Request from: Connecticut Siting Council

**PSEG Power Connecticut LLC
Petition No. 1218**

**Data Request CSC-08
Dated: 04/28/2016
CSC-08
Page 1 of 1**

SECTION 4-4
NOT TO SCALE

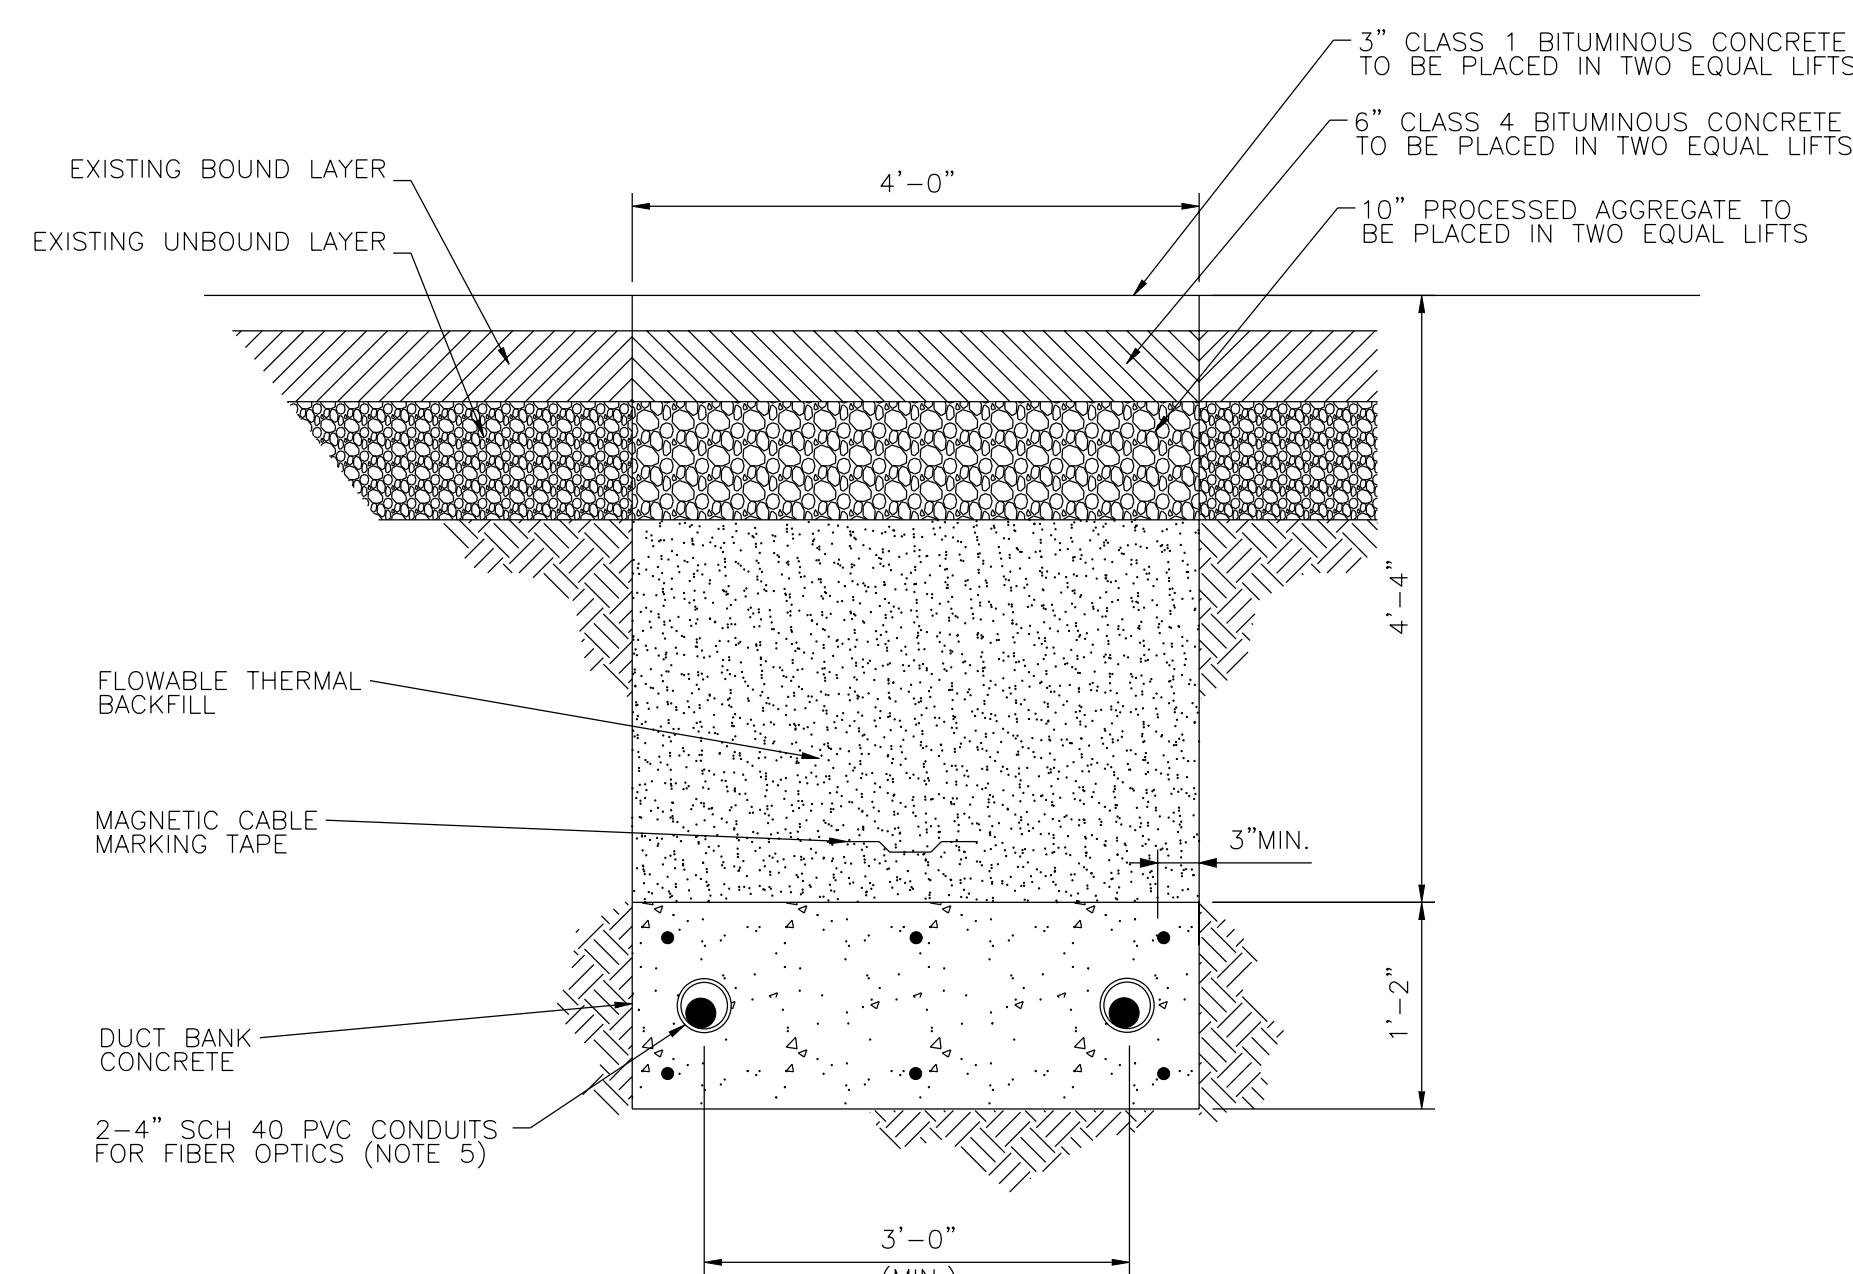
CSC-17. If the proposed project is approved, would PSEG (and/or The United Illuminating Company) file a separate petition for the 345kV underground electrical transmission cable and interconnection portion of the project or is this part of the instant Petition?

directed by underground cable to the 345 kV GIS collector bus owned by the Interconnection Customer. Subsequently, a single radial, 345 kV 3000MCM XLPE underground transmission cable will be constructed, owned and operated by the Interconnection Customer. This underground transmission cable will run from the Large Generating Facility to and in Henry Street, a public street in Bridgeport, Connecticut, to the Interconnecting Transmission Owner's Singer 345 kV substation. The Interconnecting Transmission Owner has consented to the Interconnection Customer constructing, owning and operating the single radial, 345 kV 3000MCM XLPE underground transmission cable circuit in Henry Street. The Interconnection Customer's underground transmission cable will enter the Interconnecting Transmission Owner's facility and terminate at the GIS with a high voltage cable termination. The transmission cable connection can be isolated and grounded from both ends when needed. The Interconnection Customer's 345 kV substation will use a radial arrangement with the main bus rated for 2000A, and will consist of three circuit breaker bays. Each breaker bay will have a manual disconnect switch for a visible safety isolation break from the substation main bus. A three-phase GSU is required for each of the two generators comprising the Large Generating Facility to convert from the generators' output voltage to the grid 345 kV level. The transformers are sized to carry the full capacity rating of the Large Generating Facility. A circuit breaker and disconnect switch are provided for each turbine/generator to isolate each one from its respective GSU. Isolated-Phase buses rated at 25kV and 18kV are provided to connect the unit outputs to their respective GSUs. The attached Exhibit 17-B shows the specifics of the layout and interconnection.

Natural Diversity Data Base Areas

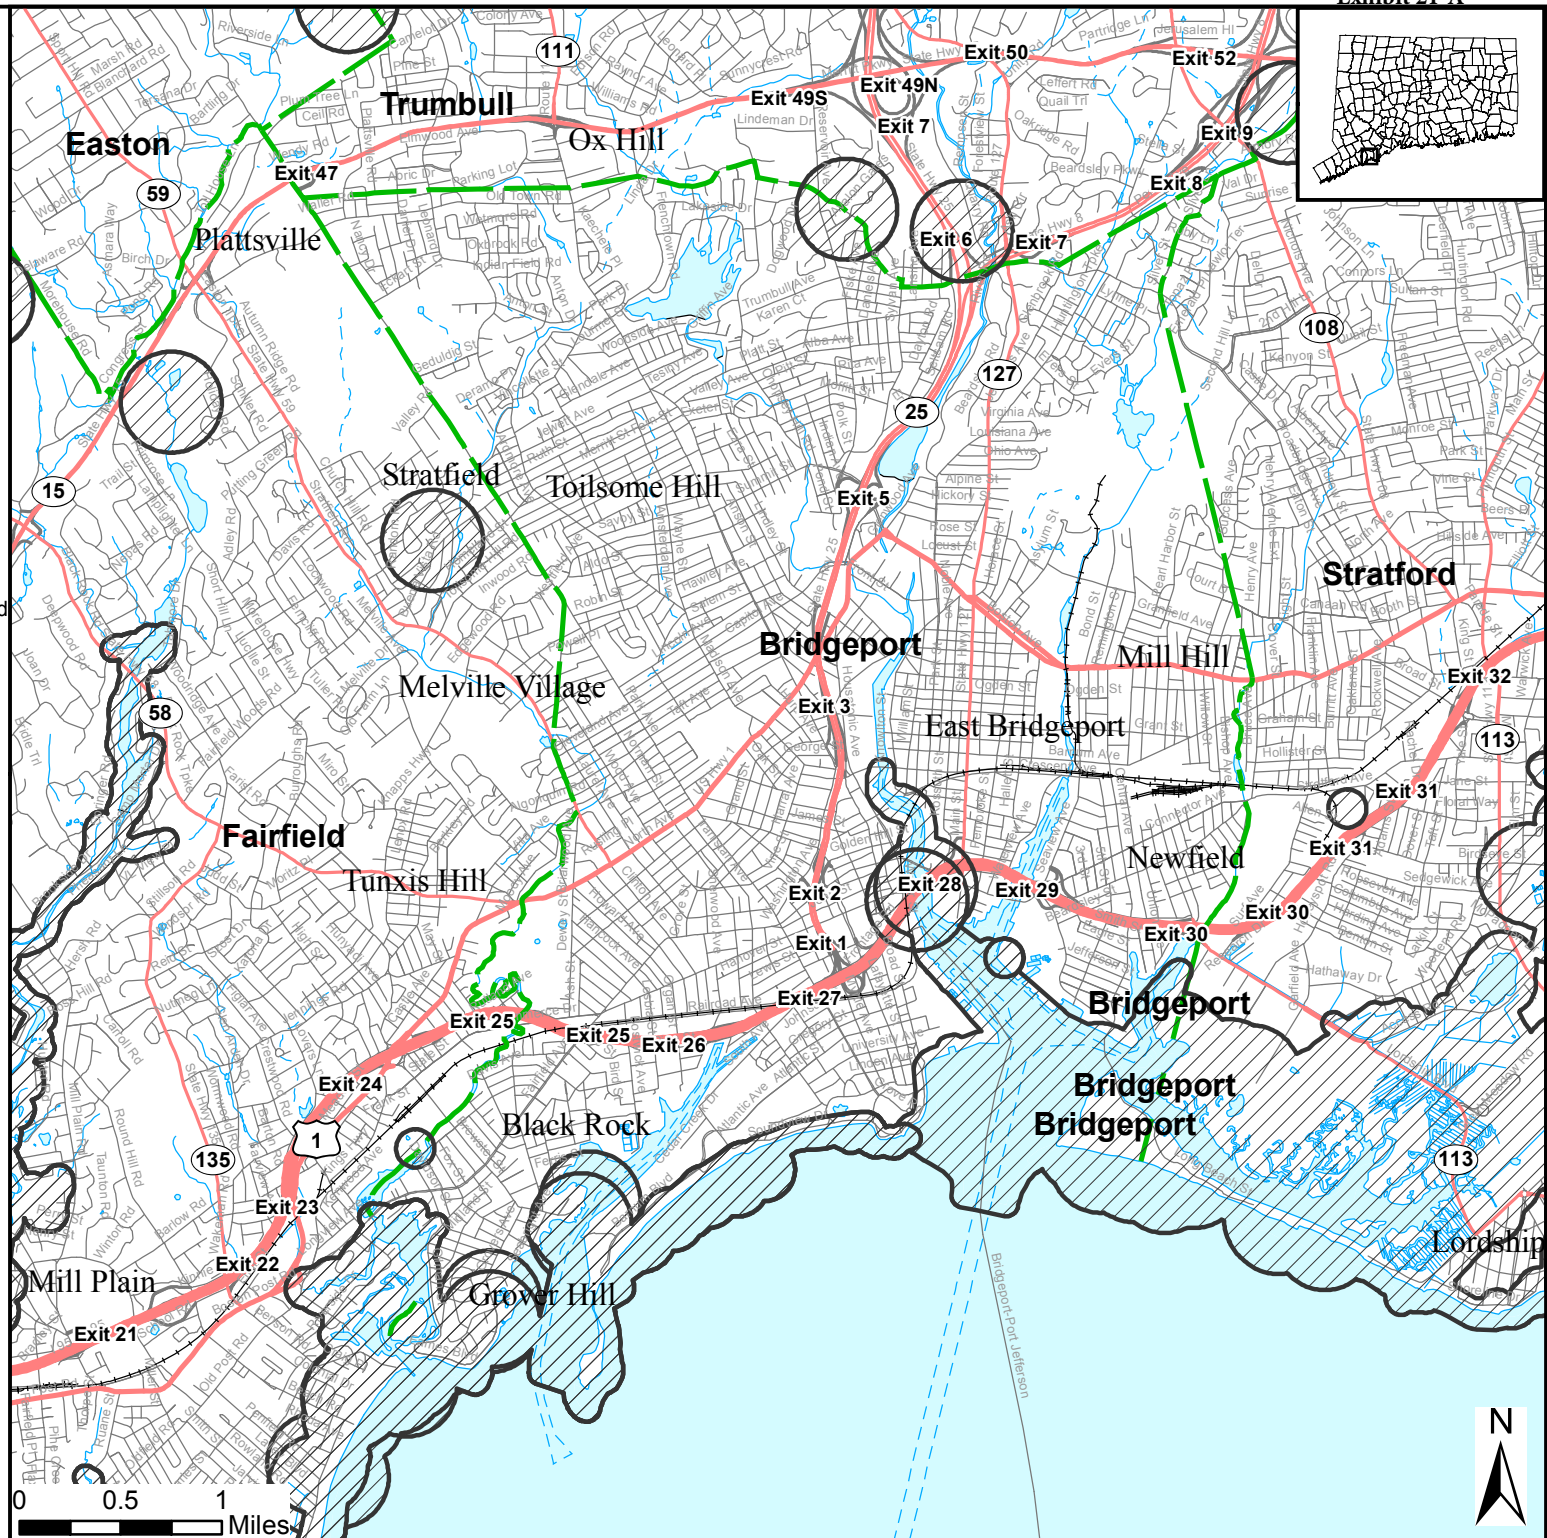
CSC-21. Is the proposed project located outside of the shaded area of the Department of Energy and Environmental Protection (DEEP) Natural Diversity Database (NDDB)? If no, has PSEG consulted with DEEP regarding the NDDB? If yes, provide a copy of any reply correspondence from DEEP.

Response: Based on the Connecticut Department of Energy & Environmental Protection (CT DEEP) Bureau of Natural Resources Wildlife Division's Natural Diversity Data Base Areas Map for Bridgeport, CT, a small portion of the proposed Unit 5 development along the southern property boundary is located within the shaded area identified as State and Federal Listed Species & Significant Natural Communities. AKRF, Inc. (AKRF) on behalf of PSEG, has conducted consultation with CT DEEP requesting a review of the proposed Combined Cycle Facility Development. AKRF received an initial response from CT DEEP on October 21, 2014 stating that given the proposed upgrades, as well as the location and siting of the proposed Facility, it is unlikely that construction activities and subsequent operations of the proposed Facility will negatively impact State-listed species. AKRF subsequently received a renewed response from CT DEEP on March 12, 2016 reconfirming that CT DEEP does not anticipate negative impacts to State-listed species resulting from the proposed activity at the site. The October 21, 2014 and March 12, 2016 CT DEEP correspondence are attached to this response.
